Staff Report to the Plan Commission

Costco Wholesale Gas Station Relocation and Parking Improvements

Project: 2025-0348 - Costco Wholesale Gas Station Relocation and Parking Improvements

Ravinia Avenue North Driveway Access

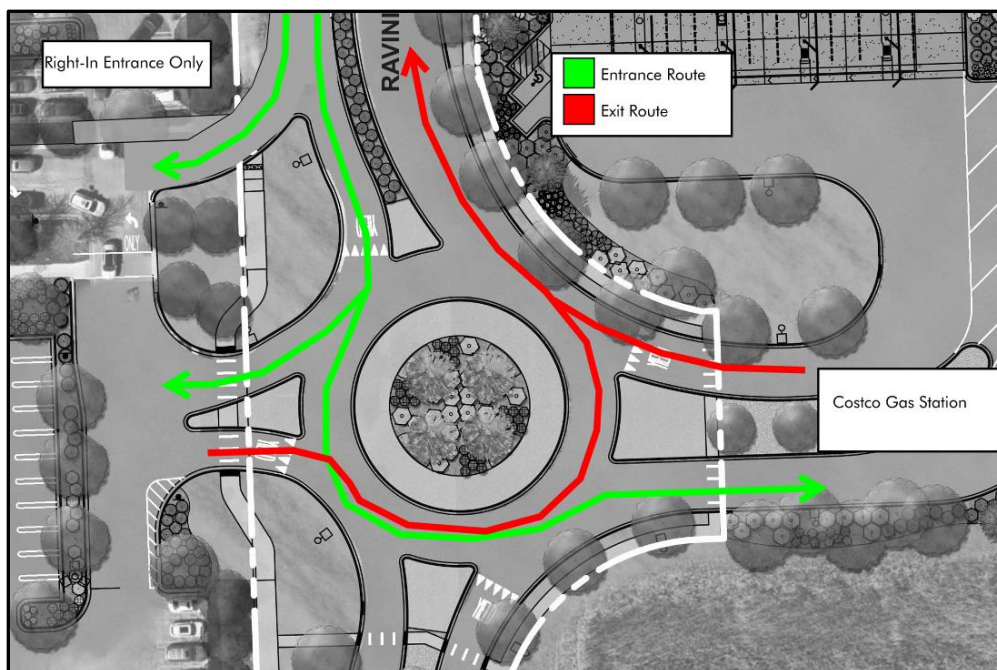
The north driveway on Ravinia Avenue currently operates as a full-access T-intersection, allowing left and right-turn movements both into and out of Costco.

As part of the site improvements, a single-lane roundabout is proposed at the intersection of Ravinia Avenue and the north entrance for the Costco warehouse and gas station. The roundabout is intended to improve traffic flow and safety by reducing conflict points and managing vehicle speeds. The traffic study, prepared by V3 Companies, last revised June 25, 2025, projects that with the roundabout in place, the intersection will accommodate projected 2050 traffic volumes. This design is expected to create efficient circulation for vehicles entering and exiting the Costco warehouse and gas station sites while reducing present delays on Ravinia Avenue.

With the proposed plan, southbound traffic on Ravinia Avenue will either turn right into the right-in-only driveway or continue through roundabout to enter Costco warehouse. All gas station traffic will enter and exit through the roundabout using the single access point.

Ravinia Avenue South Driveway Access

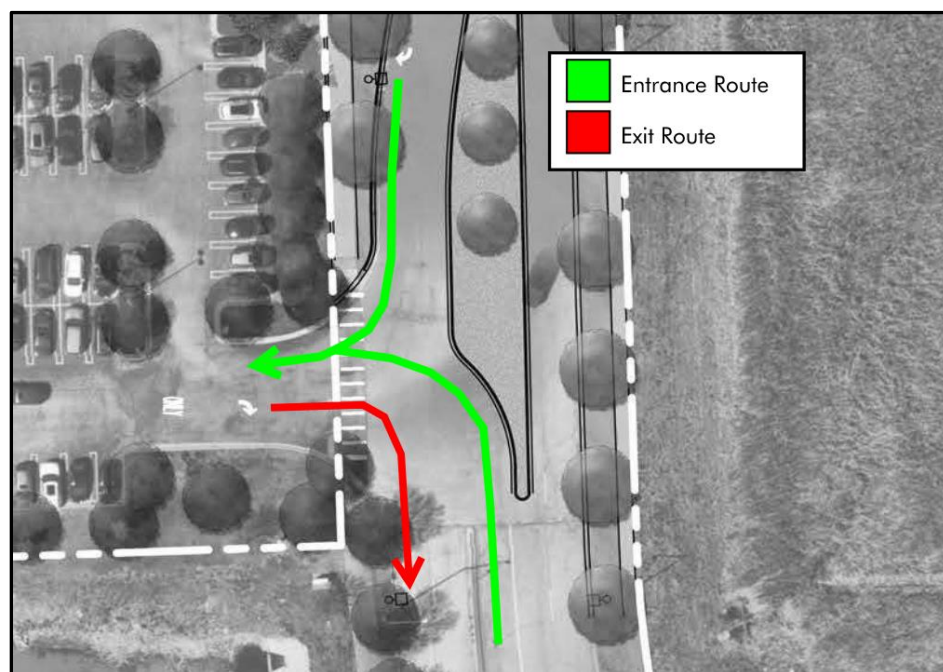
With the proposed plan, the south driveway will provide left-in, right-in, and right-out movements only. When traveling south on Ravinia Avenue, vehicles can use this driveway to enter the main Costco parking lot after passing through the roundabout. When traveling north, vehicles can use the existing left turn lane. Vehicles exiting the site at this location will only be able to turn right towards proposed 161st Street.

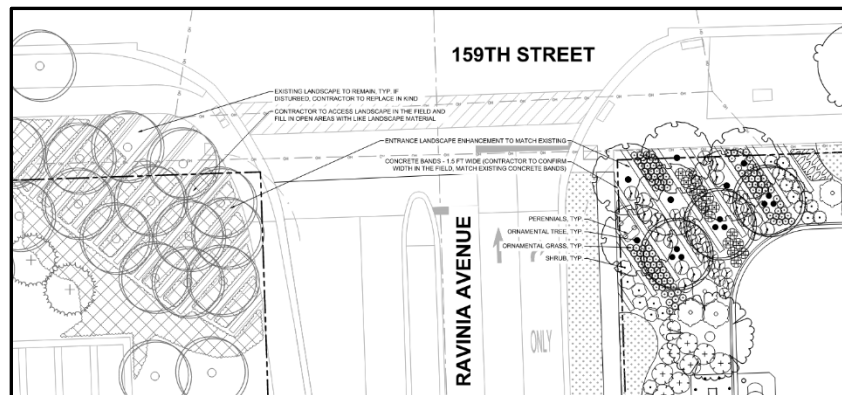
While not currently proposed on the plan, the Village is requesting that the watermain located at the southeast corner of 159th Street and LaGrange Road is extended to the east property line of the gas station parcel. This extension will ensure that future development to the east of the property can access water. Per LDC Section 6-410.B.1.e, the Developer is required to extend the water distribution system as determined by Director of Engineering. This requirement has been added as a condition of approval during final engineering.
